Docket No. 52-048

SUBJECT: NuScale Power, LLC Response to NRC Request for Additional Information No. 04 (eRAI No. 8760) on the NuScale Design Certification Application

Response to Request for Additional Information Docket No. 52-048

eRAI No.: 8760

Figure 3—202 KENO-V.a model of the spent fuel pool

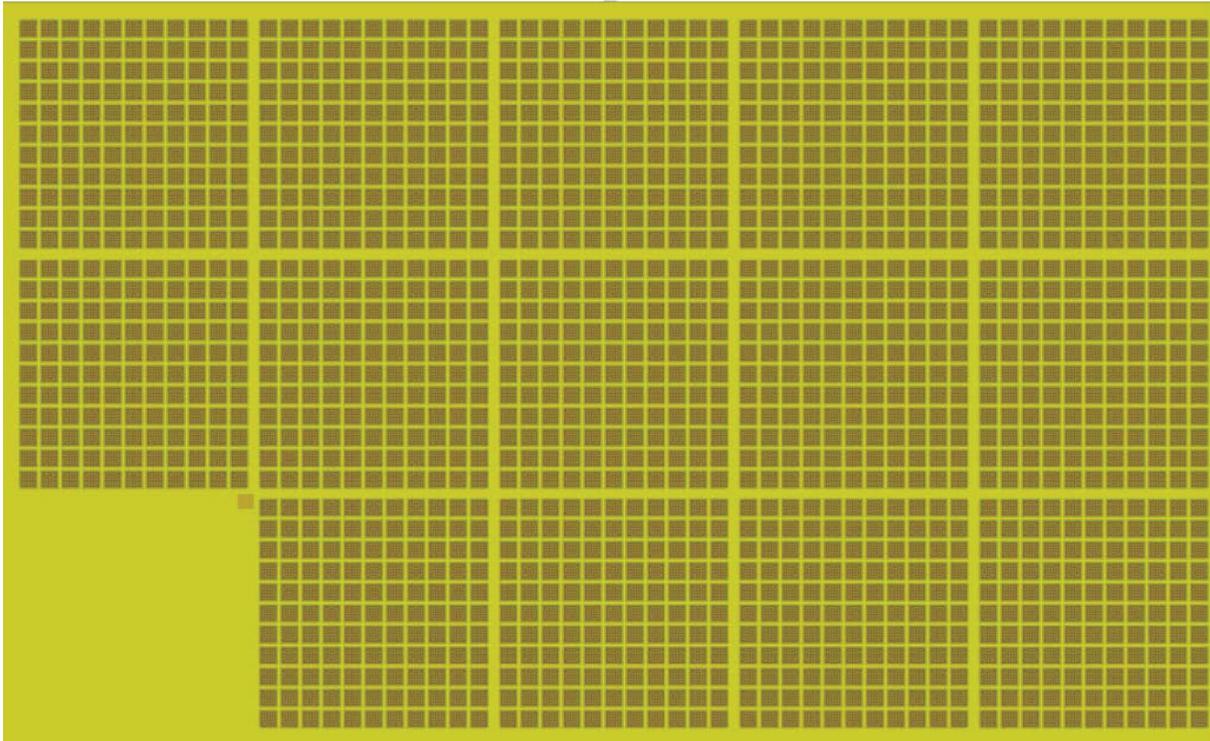
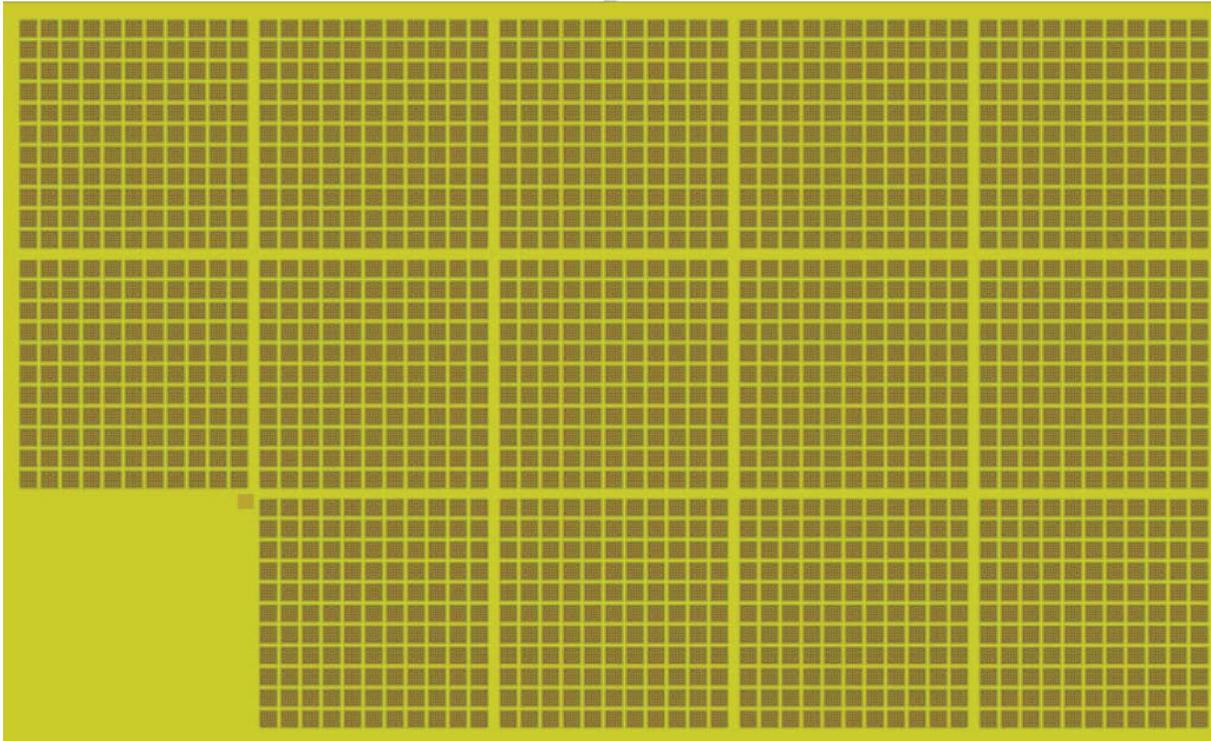
For the abnormal condition of an assembly dropped outside of the fuel storage rack, the staff observed that the current assumed location of the dropped fuel assembly, shown in Figure 3-202 of TR-0816-49833-P, does not appear to be the most limiting in terms of neutronic coupling. The staff expects that a fuel assembly dropped equidistant to and as close as possible to the three racks closest to the bottom left-hand corner of the figure would be most limiting.

Therefore, to demonstrate compliance with GDC 62 and 10 CFR 50.68, please either (a) provide justification as to why the current assumed location is conservative or (b) provide a new analysis of the more limiting location. In addition, update TR-0816-49833-P with this information accordingly.

In the original analyses, several locations were considered for the dropped fuel assembly. The variation in results was statistically insignificant. This would be expected as the relative contribution from the single dropped assembly in comparison to a full pool of fuel assemblies would be small. Additional cases were analyzed that considered a dropped fuel assembly including a fuel assembly located in the corner as described in the question, as well as directly adjacent (face-to-face) and half-way between two adjacent fuel assemblies in a rack. The cases also spanned the full width of the rack. The variation in the $k_{95/95}$ values ranged from 0.90141 (adjacent to row 1) to 0.90210 (adjacent to row 5). In reviewing the results, some corrections were also made for rack-to-rack and rack-to-dropped fuel assembly spacing. The results confirmed that the specific location of the dropped assembly is statistically

Section 3.3.6.4 of TR-0816-49833 has been revised to clarify that Figure 3-202 is a general representation of a dropped fuel assembly. Figure 3-202 has been revised to show the case described in the question and Table 3-75 has been updated with the results.

Figure 3—206 Regression analysis of fuel rod pitch

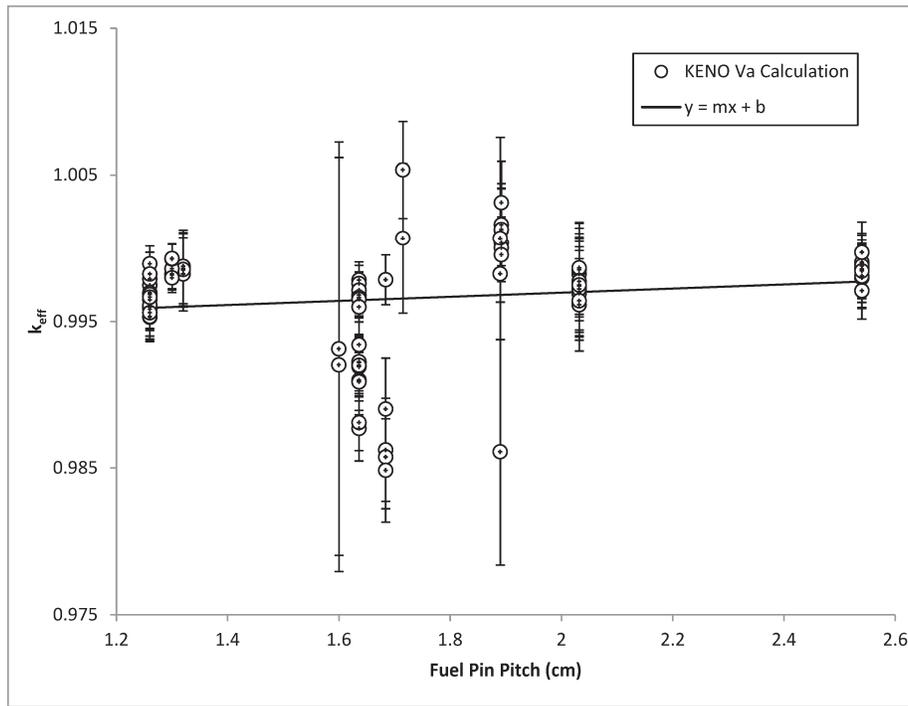
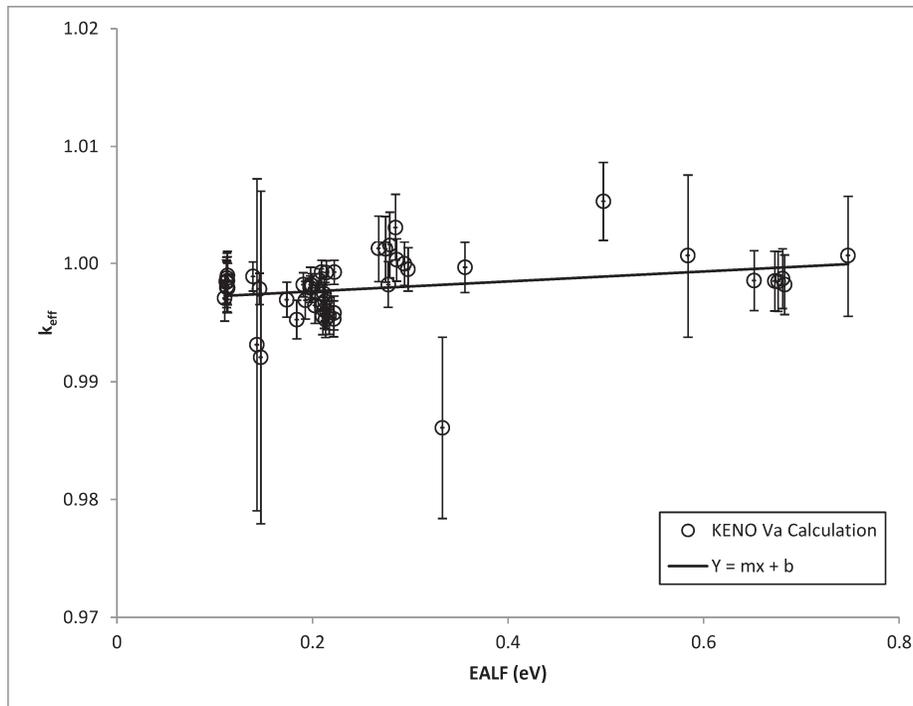
SRP Section 9.1.1 provides guidance for complying with 10 CFR Part 50, Appendix A, GDC 62 and 10 CFR 50.68. SRP Section 9.1.1 instructs the reviewer to evaluate the computational method validation to verify that the validation study is thorough and uses benchmark critical experiments that are similar to the normal-conditions and credible abnormal-conditions models and to confirm that the k-effective bias and bias uncertainty values are properly determined, including the area of applicability for maximum k-effective values.

- Figure 3-206 and Figure 3-211 were revised based on the new regression analysis for fuel pin pitch and EALF.
- Table 3-89 was revised as follows:
 - Boron areal density was changed to $3.0\text{E-}5$ to $8.7\text{E-}3$ at/barn, from $3.5\text{E-}5$ to $8.7\text{E-}3$ at/barn
